## Greensmaster® 1000

**Subject:** Cracks develop on handle.

## Installation Instructions for GREENSMASTER® 1000 Handle Support (93-3754)

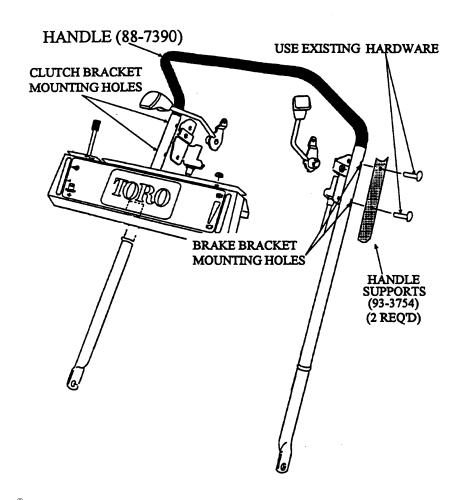
Cracks may develop at the operating lever mounting holes in the handle on these units. This condition is directly related to the bouncing that occurs when the unit is transported in trailers over rough terrain. If you operate your units in this way and notice this condition on a unit listed above, the area susceptible to cracking can be strengthened. Handle Support (93-3754) is available through your local Toro distributor for this purpose. Two supports are required for each machine.
